HPB23-0575
September 12, 2023

LINCOLN ROAD RENEWAL

Easier Pedestrian Beach Access

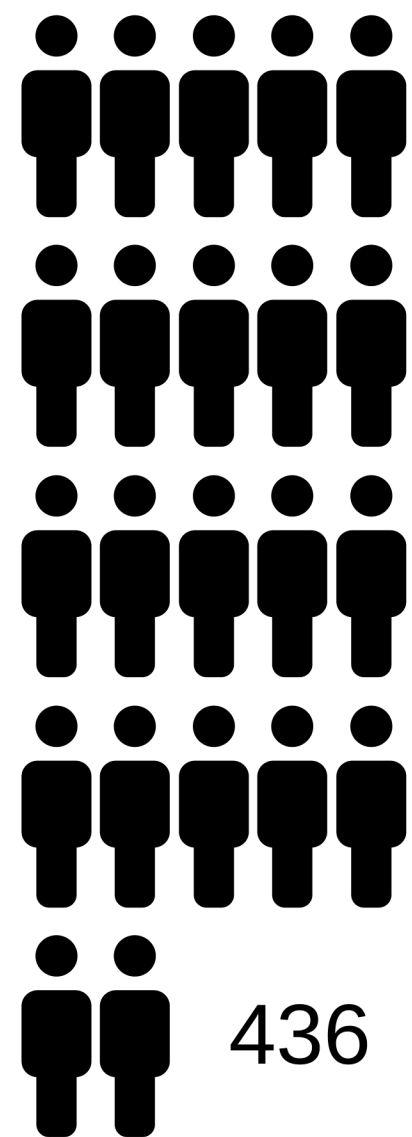
generally supportive of the gateway design; however, staff recommends that the paving be expanded to the north to provide a safer and smoother transition (especially for bicyclists) from Lincoln Road to the Beachwalk.

1. Revised elevation, site plan and floor plan drawings shall be submitted and, at a minimum, such drawings shall incorporate the following:
 - a. The pedestrian walkway paving shall be expanded to the north of the gateway structure to provide a smoother transition from Lincoln Road to the path to the Beachwalk, in a manner to be reviewed and approved by staff consistent with the Certificate of Appropriateness Criteria and/or the directions from the Board.

Proposed

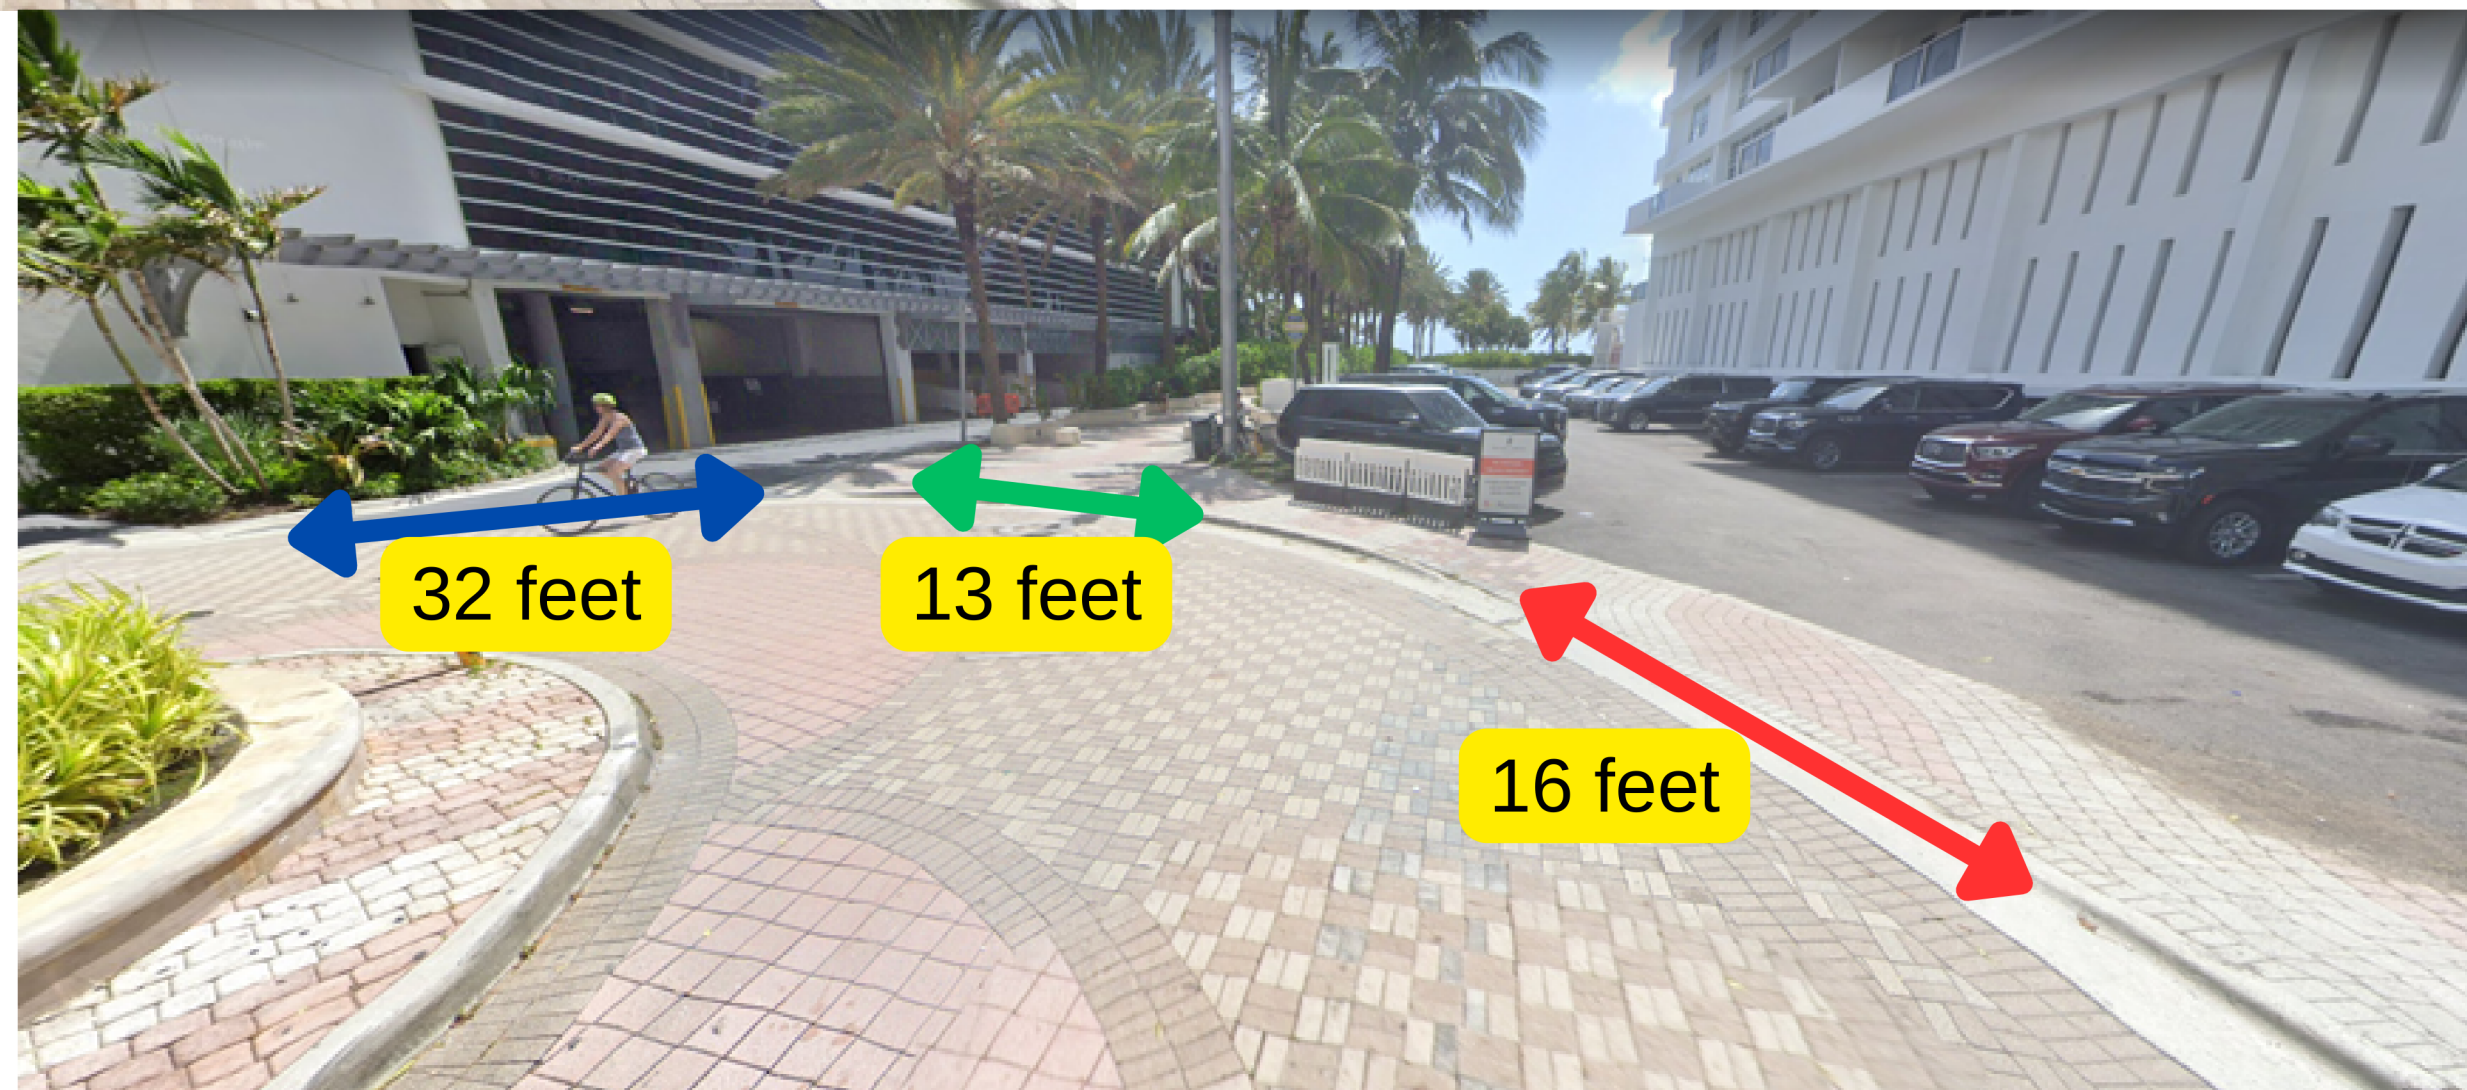
Among the busiest beach and beachwalk entrances that deserves a design that prioritizes pedestrians – and meets or exceeds current conditions

Maneuverability Analysis (SU40)

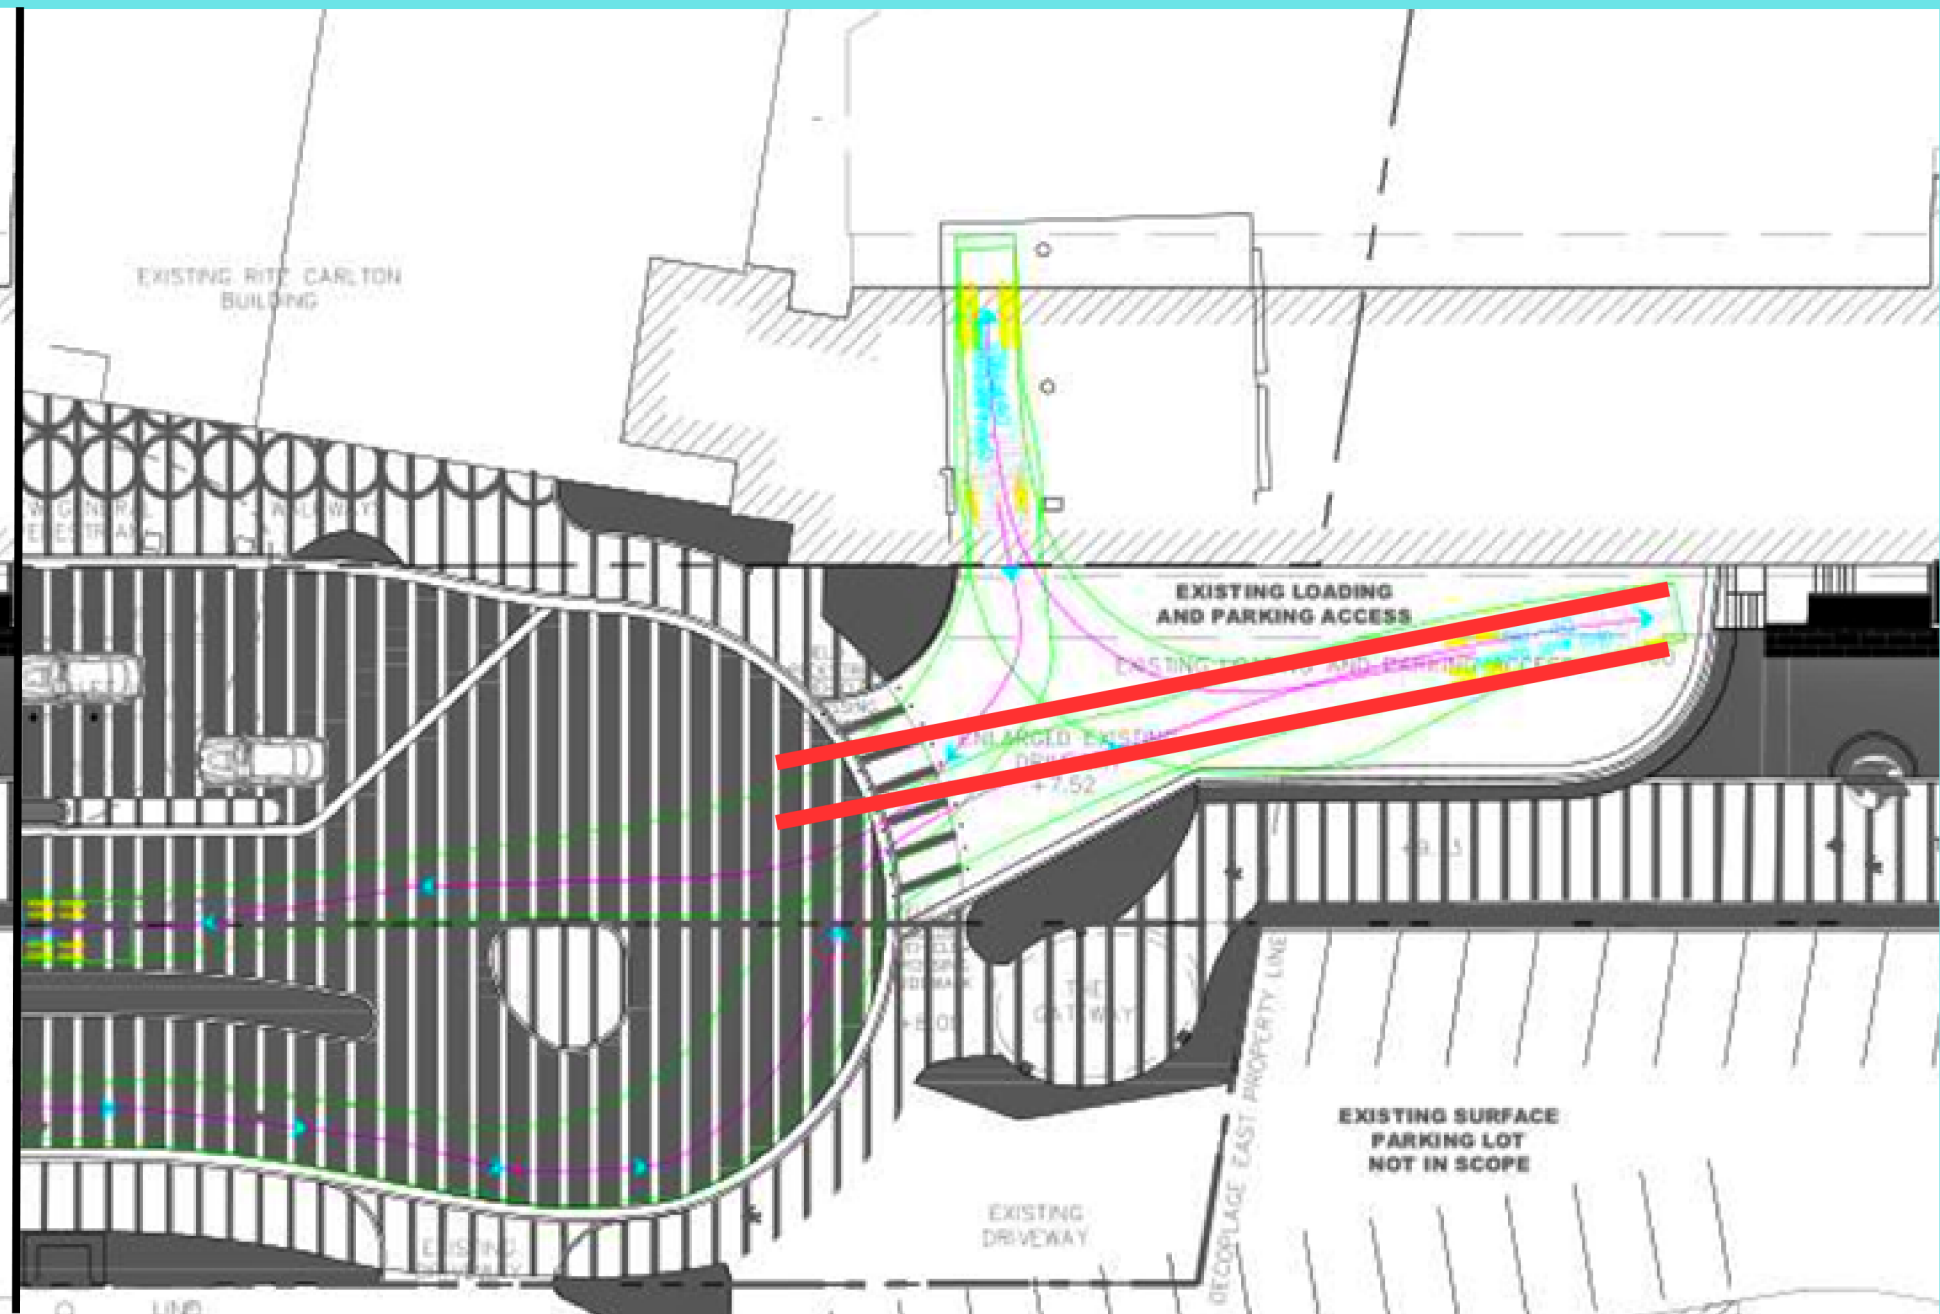
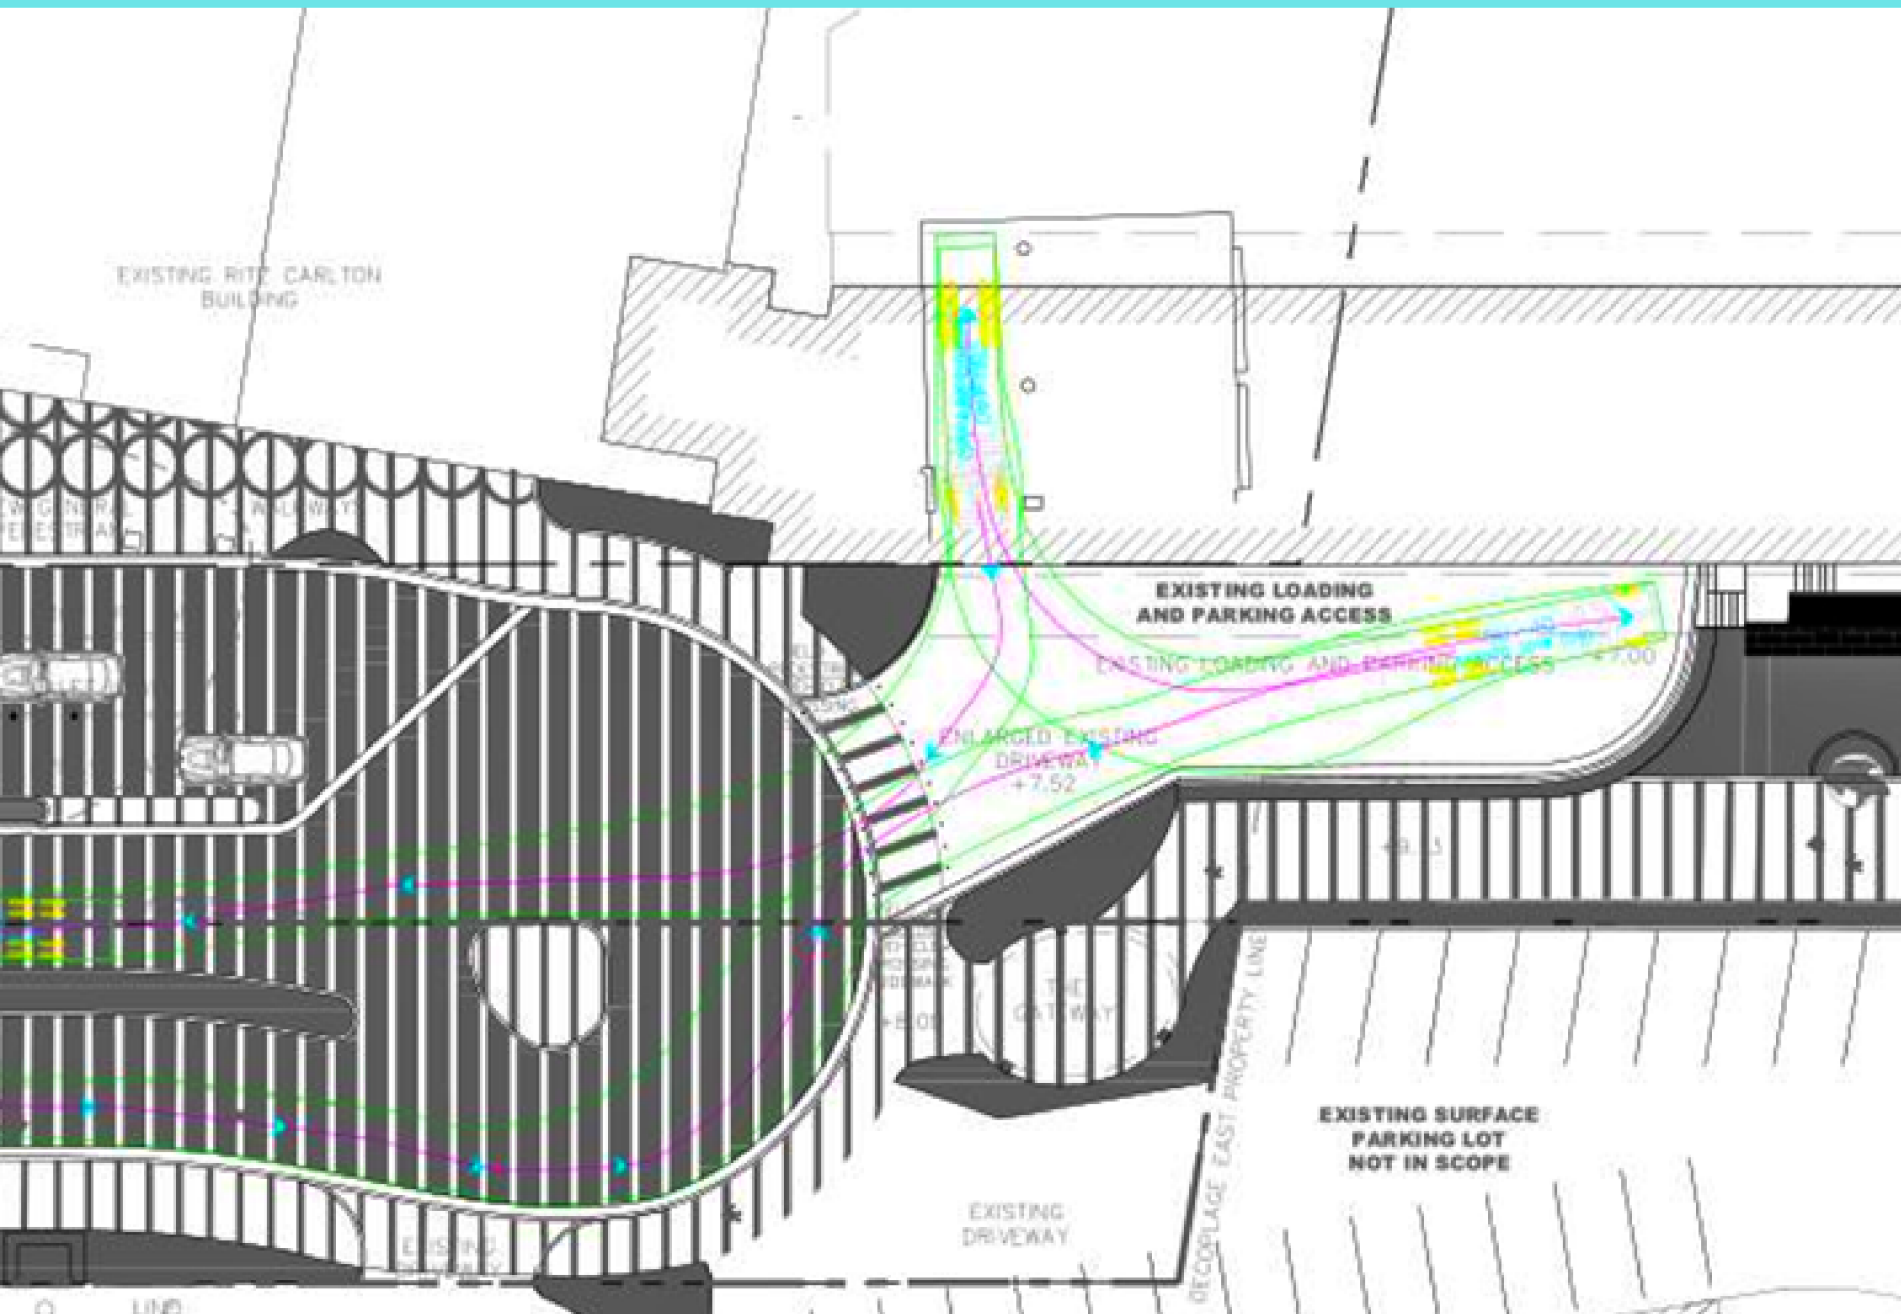
32 Feet (Proposed)

Less Than 32 Feet
(Alternative)

Loading Driveway width increases from 20' to 32'

Beach access path, at street end, decreases from approx. 24' to 13'

Direct applicant to work with stakeholders & staff to refine street-end design to be more appropriate and balanced than proposed
